# Product Change Notification - SYST-04NMLU519

**Notification subject:**
ERRATA - USB251xB/xBi Family Silicon Errata
**Notification text:**
SYST-04NMLU519
Microchip has released a new DeviceDoc for the USB251xB/xBi Family Silicon Errata of devices. If you are using one of these devices please read the document located at USB251xB/xBi Family Silicon Errata.

**Description of Change:**
1) Added new errata module “Detach detection failure”.
2) Updated layout to standard Microchip format.

## USB251xB/xBi Family Silicon Errata

**FIGURE 1: RC CIRCUIT DIAGRAM**

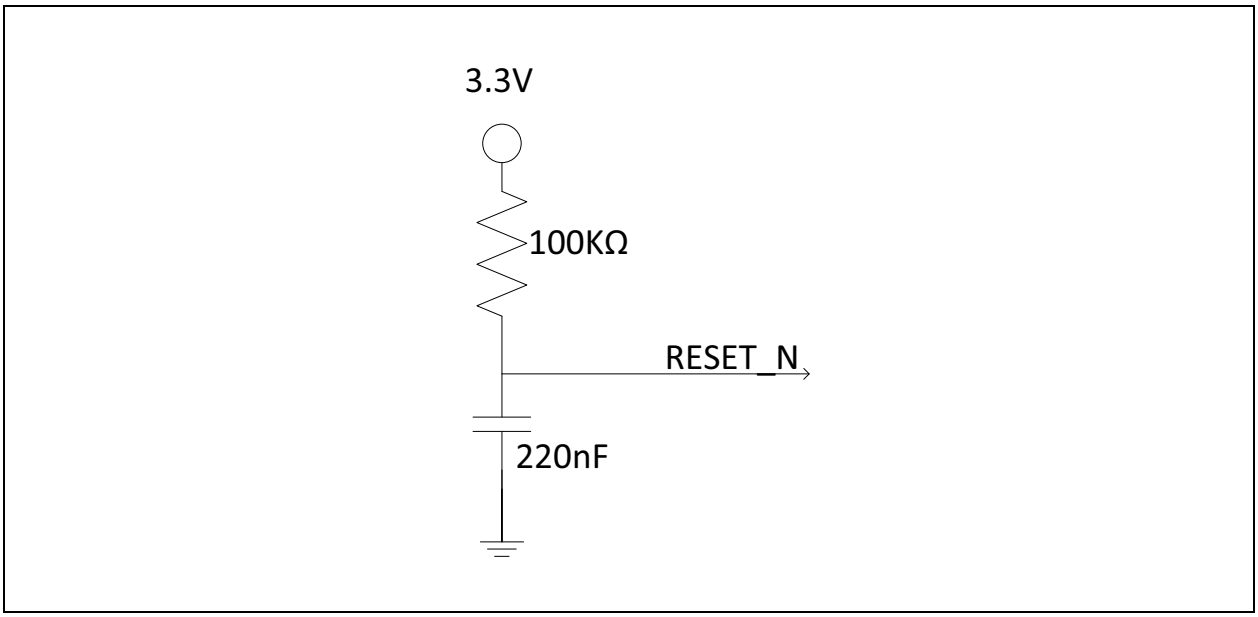
### Module 3: Glitch on DP (and SD/SCL) during power-up

When the Hub is powering up, the DP pin is asserted before other internal logic has started. When the internal logic does start, it can cause a low pulse on the SMBus and DP pins.

The USB protocol can handle a glitch on DP, so no user impact on the USB lines. The SMBus glitch can impact the state machine of the SMBus Controller.

Keep the RESET_N pin low during POR to remove this glitch. Control RESET_N through a digital controller or an RC circuit by connecting a 100KΩ pull-up resistor to 3.3V and a 220nF capacitor to ground. See RC circuit diagram below.
